The Town of Hilton Head Island Regular Design Review Board Meeting

AGENDA

DESIGN TEAM/ DRB COMMENT SHEET

PROJECT Reilley's South DRB# DR100035

FIRST PRESBYTERIAN CHURCH
 IDENTIFICATION SIGN

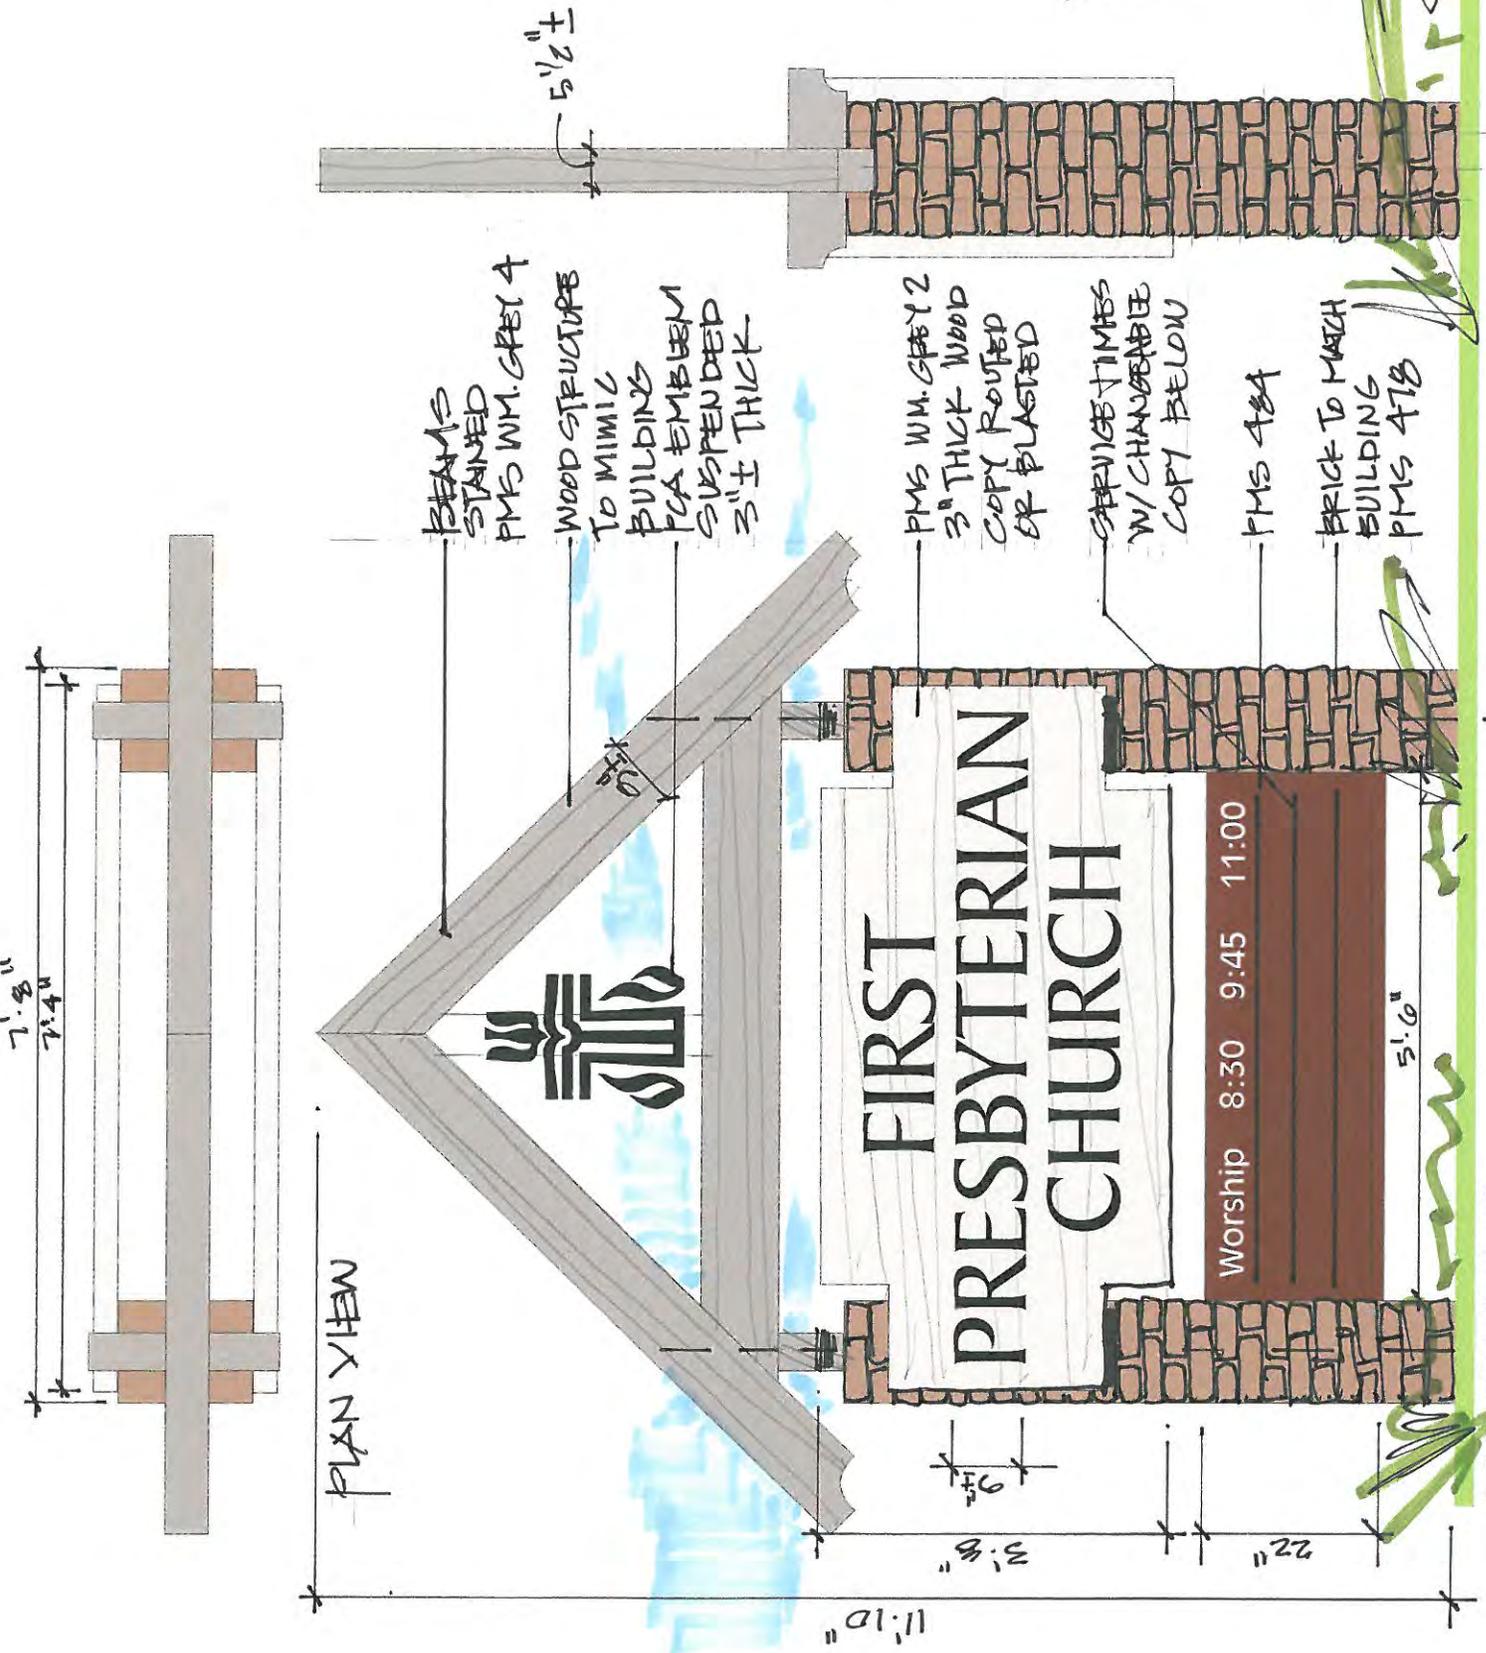
FREE STANDING SIGNS		
DESIGN GUIDE/LMO CRITERIA	COMPLIES YES/NO/N/A	COMMENTS OR CONDITIONS
SIGN FACE IS 3 DIMENSIONAL	YES	
TENANT PANELS LIMITED TO 3 OF SAME SIZE, FONT AND COLOR AND COMPRISE NO MORE THE 1/3 OF THE SIGN FACE	YES	
LOGOS DO NOT EXCEED 10% OF SIGN FACE AND VIVID COLORS ARE LESS THAN 10% OF LOGO	YES	
LIGHTING IS SHIELDED BY THE SIGN OR PLANT MATERIAL	YES	
LANDSCAPING IS ADEQUATE FOR SIZE OF SIGN	YES	
FAÇADE SIGNS		
DESIGN GUIDE/LMO CRITERIA	COMPLIES YES/NO/NA	COMMENTS OR CONDITIONS
MEETS LMO 16-5-1309 SIZE CRITERIA		
ONLY 2 SIGNS PER FAÇADE (EXCEPT FOR SHOPPING CENTERS)		
COMPLIES WITH SIGN SYSTEM IF SHOPPING CENTER		
CONTAINED WITHIN AN ARCHITECTURAL ELEMENT OF THE BUILDING		
IS SIMILAR IN DESIGN AND CONTENT OF FREE STANDING SIGN(S)		
SIGN HAS 3 DIMENSIONAL FACE		
LOGOS DO NOT EXCEED 10% OF SIGN FACE AND VIVID COLORS ARE LESS THAN 10% OF LOGO		
LIGHTING IS SHIELDED FROM THE PUBLIC WAY		
MISCELLANEOUS LMO REQUIREMENTS (REQUIRED)

CRITERIA	YES/NO/NA	
DOES NOT CONTAIN MORE INFORMATION THAN NECESSARY TO PROVIDE REASONABLE IDENTIFICATION OF THE BUSINESS	YES	
MATERIALS, COLORS, SHAPES AND DETAILS REFLECT THOSE OF THE BUILDING	YES	
SIZE AND PROPORTION DOES NOT DOMINATE SITE	YES	
SIZE AND PROPORTION IS COMPATIBLE WITH NEARBY AND ADJACENT PROPERTIES	YES
